<b>Countries:</b>	CANADA, UNITED STATES, PUERTO RICO	<b>Document ID:</b>	IK1600018
<b>Availability:</b>	ISIS	<b>Revision:</b>	3
<b>Major System:</b>	CAB / SLEEPER / HOOD	<b>Created:</b>	4/20/2007
<b>Current Language:</b>	English	<b>Last Modified:</b>	3/12/2014
<b>Other Languages:</b>	<a href="#">Français</a> , <a href="#">Español</a> ,	<b>Author:</b>	Patrick Gotschall
<b>Viewed:</b>	311

**Title: Door Hinge Hard to Open on 5000's and 9000's**

**Applies To: All 5000 models built prior to 6/2/06, 9000 models (CAP) built prior to 5/24/06 and (EAP) built prior to 6/19/06**

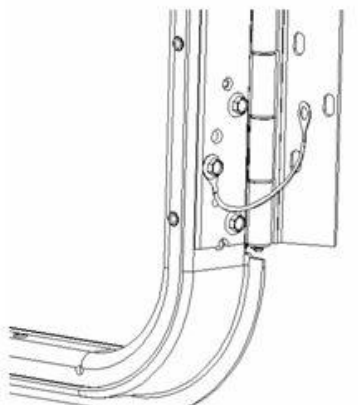
The presence of brass bushings accelerated corrosion within the hinges.

**Brass bushings in prior design provided conductivity for grounding of the CB antenna. The ground strap provides this functionality with the elimination of the brass bushings.**

To correct this, replace the old part with the new one listed below:

- 3513636C4 Hinge, Door SD W/Nylon Bushing
- 3803792C1 Strap, Door Hinge Ground

Replace hinge with new part number, ensuring that the ground strap is installed as shown.
